**Wisconsin Public Service Corporation**  
 (a subsidiary of WPS Resources Corporation)  
 Kewaunee Nuclear Power Plant  
 North 490, Highway 42  
 Kewaunee, WI 54216-9511  
 920-388-2560

Docket 50-305  
 Operating License DPR-43  
 Kewaunee Nuclear Power Plant  
Proposed Technical Specification Amendment Request PA #167 Spent Fuel Storage –  
Response to Additional Information

## **Requests For Additional Information**

Figure 1: Velocity vectors (ft/s) in a plane through the center of the Kewaunee transfer canal racks (Partial Core Discharge Scenario)

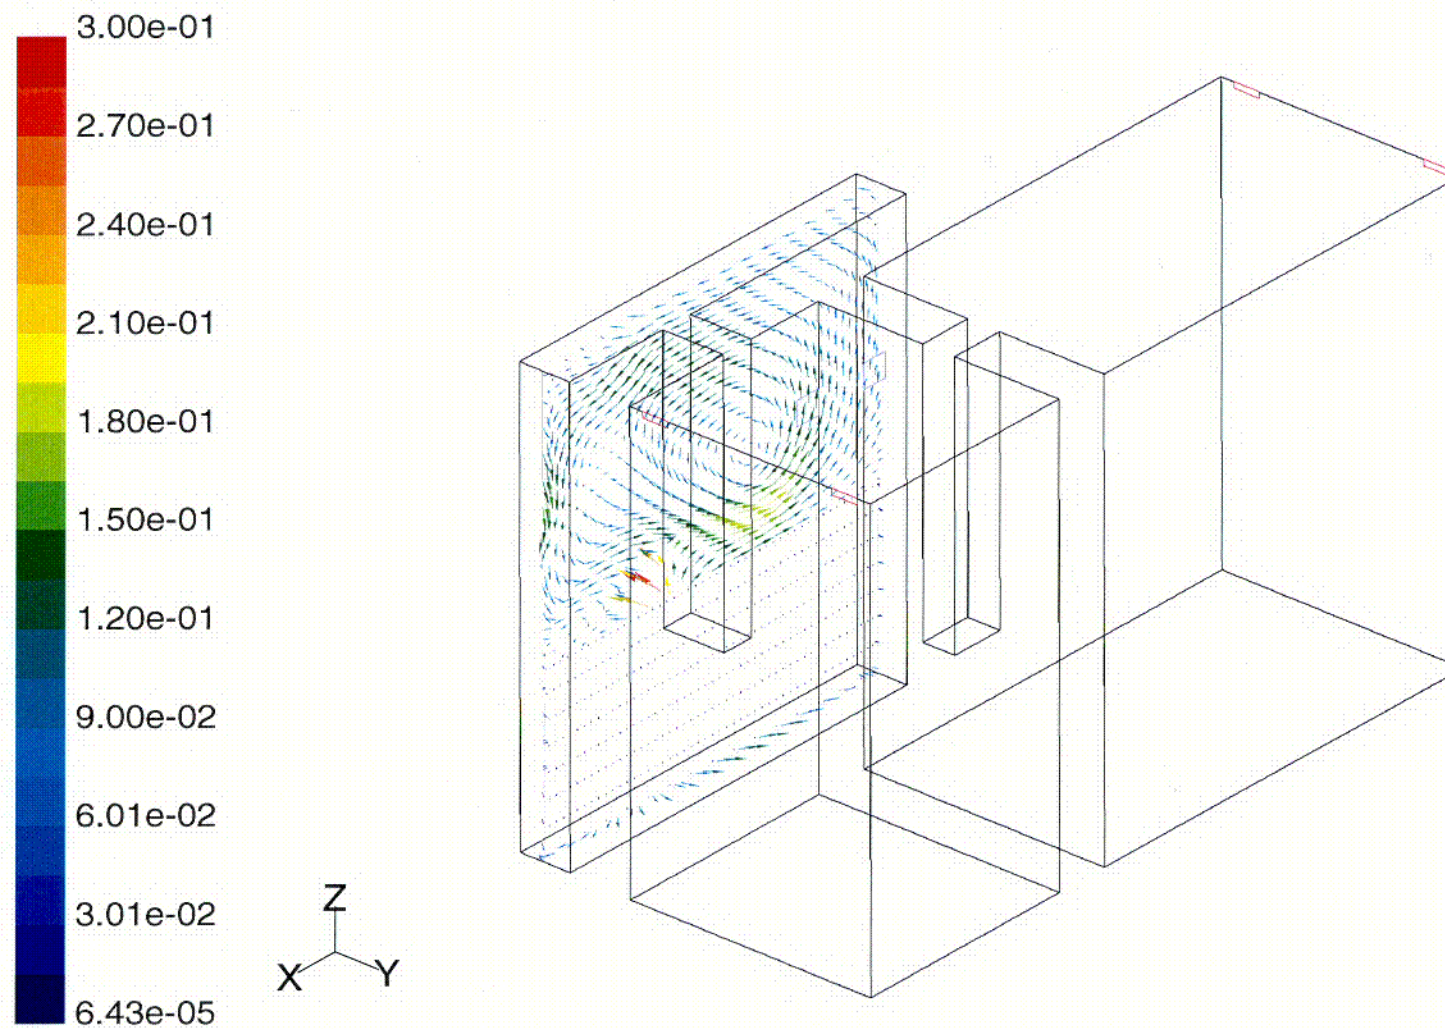
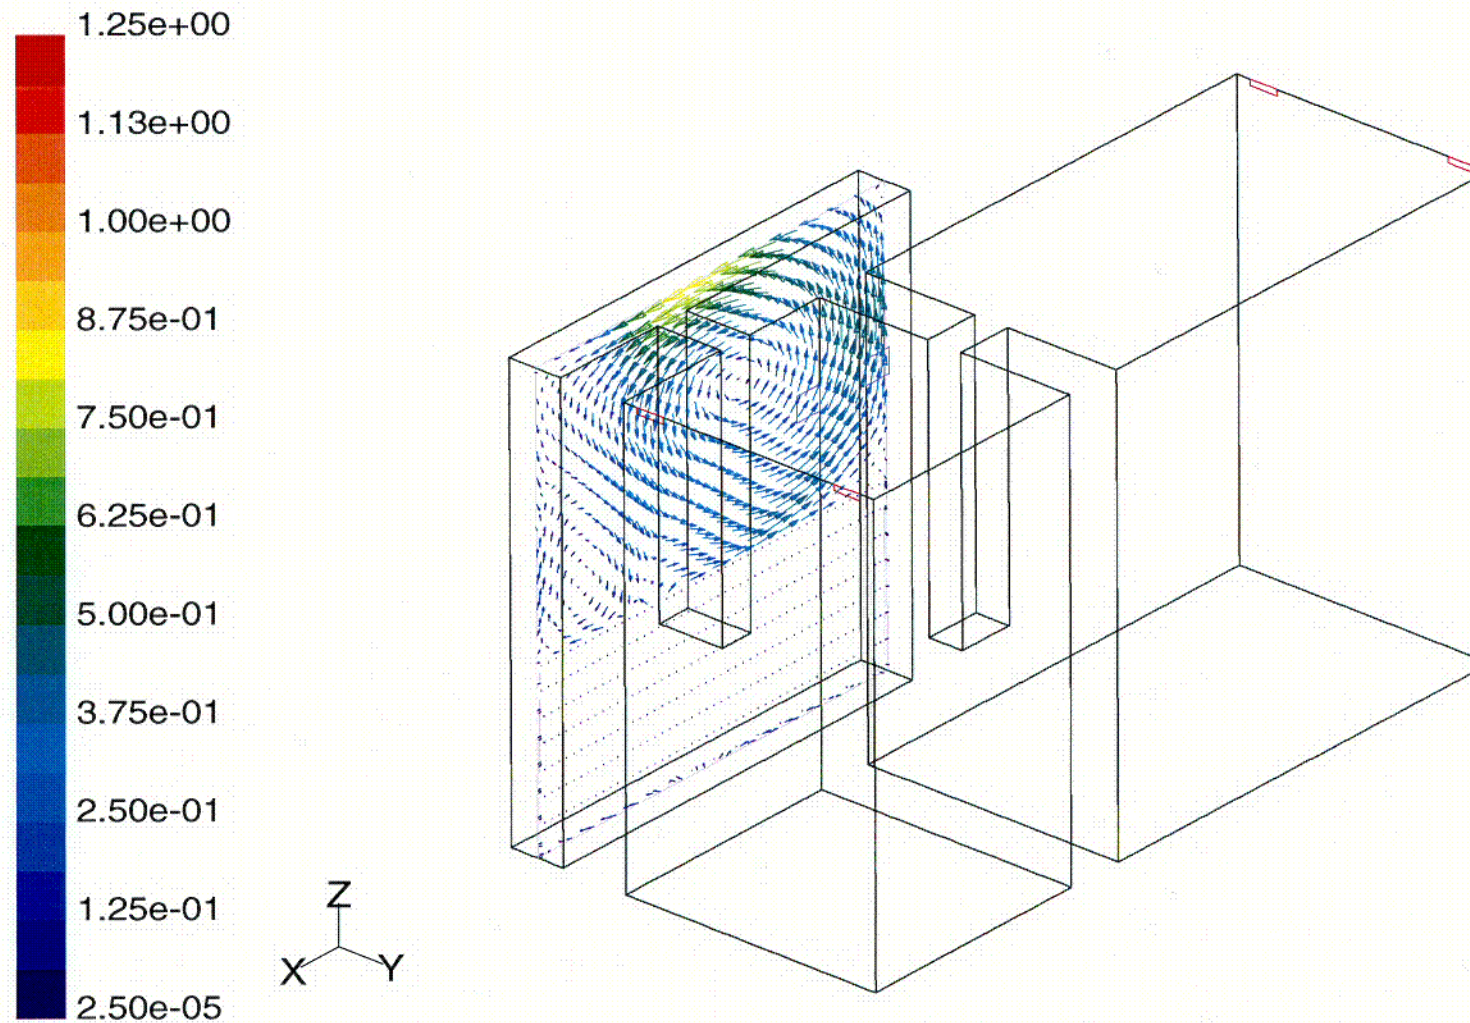
The new storage section in the north transfer canal is connected to the main pool through a relatively narrow slot. This new storage area does not have direct cooling. Although this new storage area is cooled by natural convection through this slot (Page 5-18, Attachment 5), it is not obvious that this cooling is adequate. Please provide the temperature and velocity distributions in the new storage section through the middle plane in the north-south direction (similar to that shown on Figure 5.8.2). Explain the mechanism how this section is cooled using the above temperature and velocity profiles. What is the estimated maximum temperature difference between this section and the pool bulk temperature? What are the dimensions (width and height) of the transfer slot? Are there any temperature monitors in the new storage section?

Figures 1, 2 and 3 present the velocity vectors in a vertical plane through the middle of the transfer canal racks for the partial core, full core and emergency full core discharges, respectively. Figures 4 through 6 present the corresponding temperature contours in the same plane.

Although not identical, the velocity vectors in Figures 1 through 3 all show a similar pattern; water from both ends of the new storage section flows toward the slot that connects the new storage section to the north spent fuel pool. The general pattern is that the heated water issuing from the top of the racks is swept horizontally across the top of the racks toward the north and south ends of the new storage section, where it rises toward the water surface and flows to the slot. This demonstrates that there is a vigorous, passive mechanism for moving heated water from the fuel assemblies in the new storage racks through the slot and into the north spent fuel pool, where it can be subsequently transferred to the SFPCS.
